# NOTE TO FILE

JBA Project Code 2020s1397  
Contract Julian Terrace Flood Modelling  
Client Kennedy James Griffiths  
Day, Date and Time 27 July 2021  
Author Paul Redbourne  
Subject Julian Terrace Flood Modelling - REVB

JBA Consulting were commissioned by Kennedy James Griffiths in October 2020 to undertake a flood modelling study to gain a better understanding of the impact of flooding and potential displacement of flood water onto third parties from a development on Julian Terrace in Port Talbot. The proposed development consists of a ground floor commercial unit and two first floor residential units.

**Figure 3-3 Post-development scenario, 1% AEP plus climate change event - Maximum Depths**

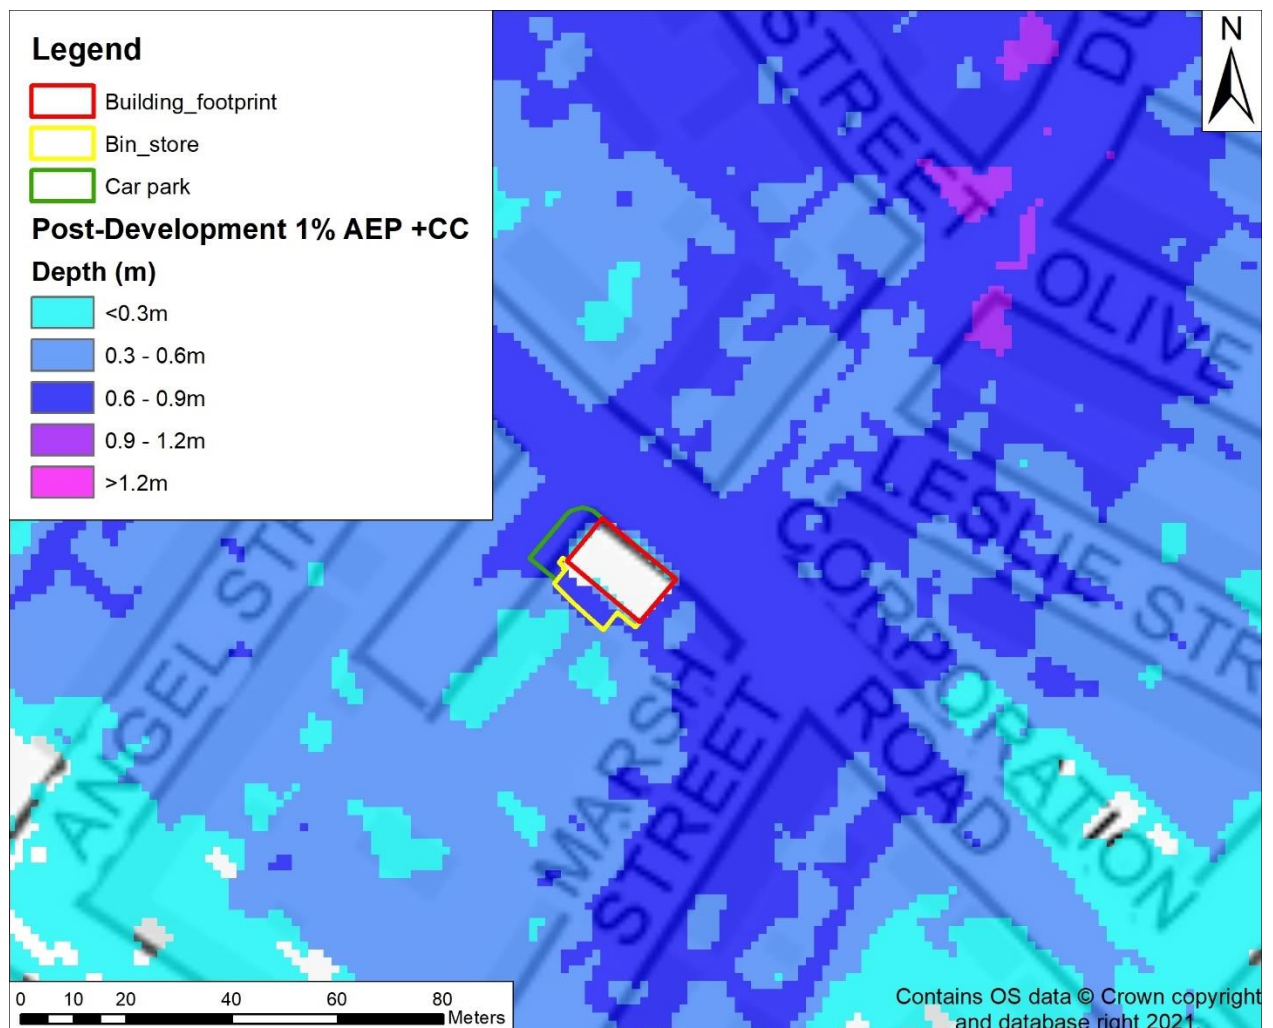
The car park area was set to a level of 4.87mAOD. This level has been chosen so that it aligns with the surrounding ground levels along Julian Terrace Road. NRW have queried why the car parking is not set to the same FFL elevation of the commercial unit (5.68mAOD). Unfortunately, it is not practical to raise the park spaces any further whilst providing a suitable tie-in with the adjacent highway. The vacant lot is currently used for car parking and only one of the park spaces is proposed to be allocated to the residential unit, the rest shall be allocated to the commercial property (less vulnerable development).

In order for the development to be compliant with TAN 15, the building finished floor level has been raised to 5.68mAOD during the post development scenario so that it is free from flooding during the 1% AEP plus climate change event.

During the 1% AEP plus climate change event, the building remains free from flooding, while a maximum depth of 0.80m is experienced in the car park. The depth results for the post development scenario during the 1% AEP plus climate change event are shown below in Figure 3-3. The figure suggests that there is a small amount of flooding inside the building footprint for the 1% AEP plus climate change event. This is attributed to the modelled grid size and grid orientation. The modelled peak water level is 5.67mAOD which is below the recommended finished floor level and therefore the building is not actually experiencing flooding in this event.

**Figure 3-10: 1% AEP plus climate change blockage**

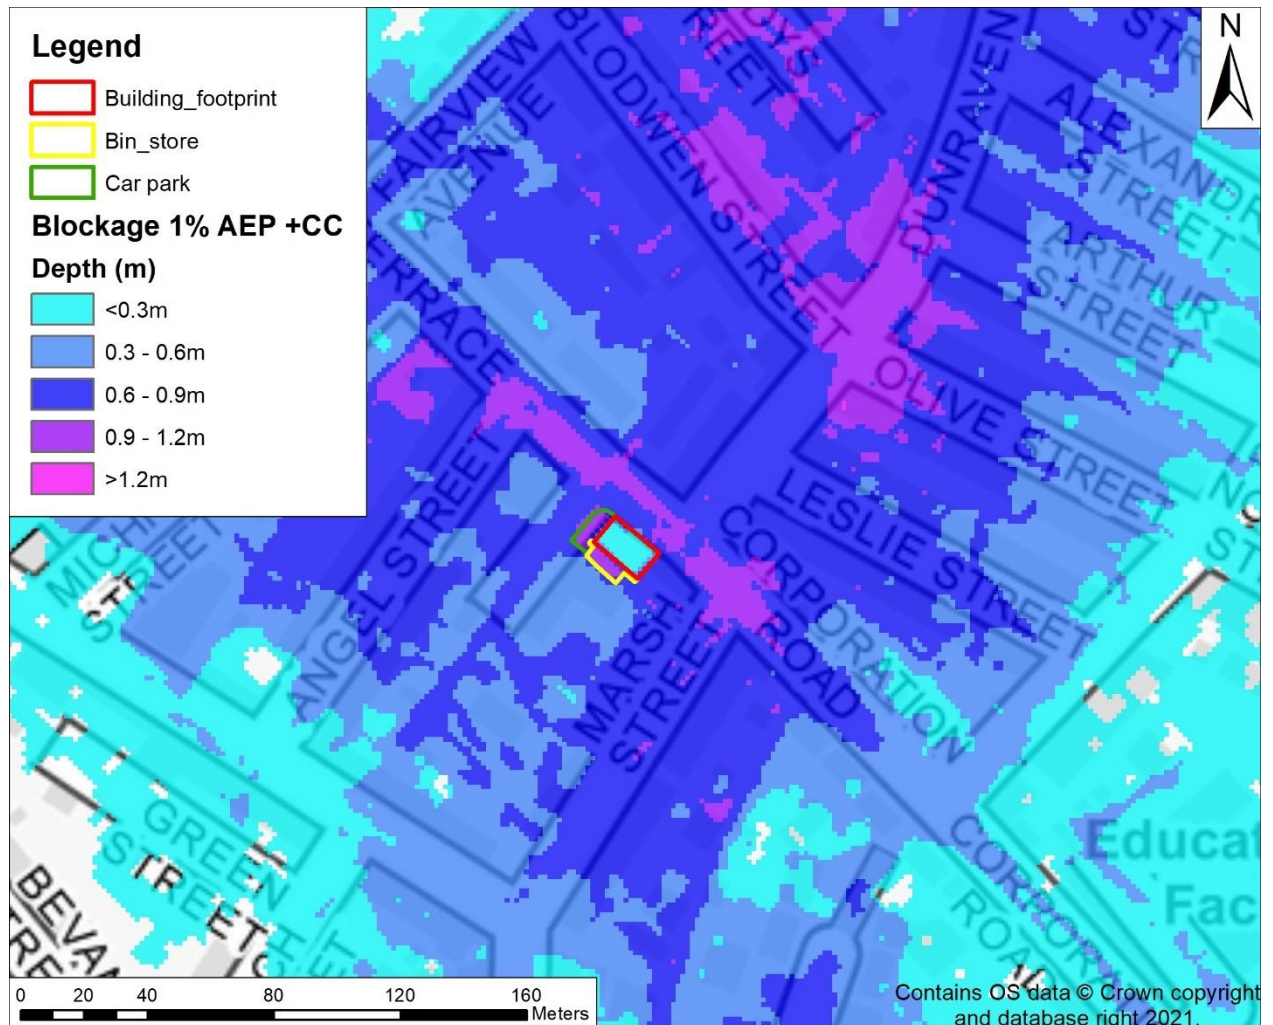
NRW requested the inclusion of blockage simulations to understand the residual risk associated with blockage of the triple arch bridge located at the end of Station Road. A blockage percentage of 25% has been applied to represent NRW's medium risk scenario for bridge blockage.

Figure 3-10 shows the modelled flood depths for the 1% AEP plus climate change with the application of blockage to the Station Road bridge. The application of blockage causes an increase in out of bank flooding which will result in the proposed building footprint flooding to a maximum depth of 0.15m in the 1% AEP plus climate change event.

In terms of flood hazard, the peak hazard classification found within the building footprint in the 1% AEP plus climate change event with the application of blockage is 0.58. This value constitutes very low hazard which implies caution should be taken.

**Figure 4-1: 2021 0.1% AEP Baseline flood depth**

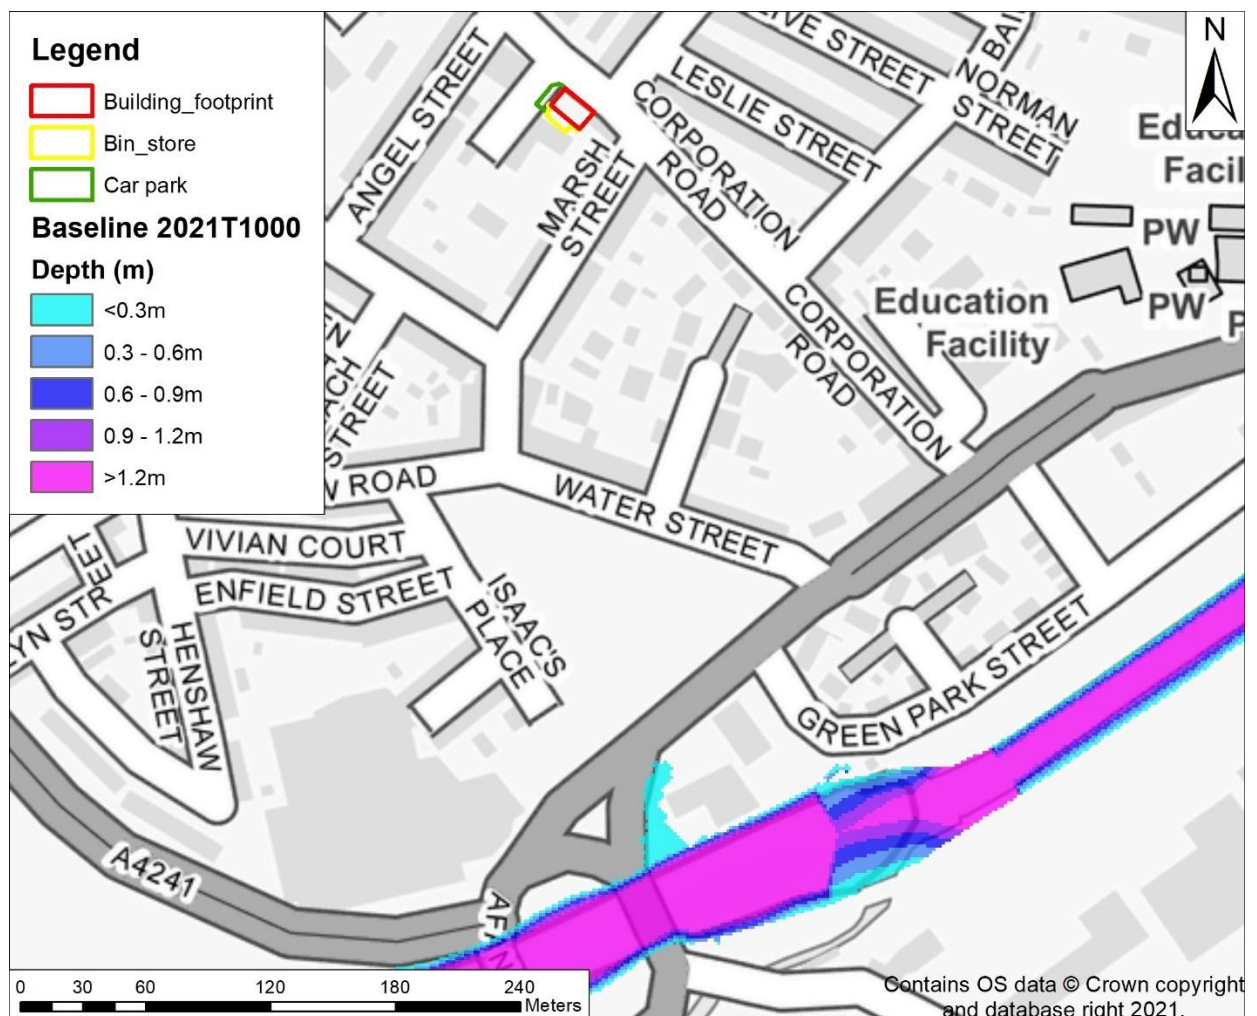
NRW have highlighted in their review that the Julian Terrace flood modelling work had not included any assessment of tidal flood risk. As describe in section 2.1, new tidal boundaries have been generated for the Port Talbot model and design event simulations have been completed for the 0.5% and 0.1% AEP events looking at present day flood risk and with the application of climate change.

In the present-day design event simulations, there is no tidal flood risk to the site in either the 0.5% or 0.1% AEP events as shown in Figure 4-1. This shows the maximum flood depth for the present day (2021) 0.1% AEP event. Due to there being no tidal flood risk in the present-day design event simulations, it was decided not to undertake post-development simulations for the present-day tidal design events.
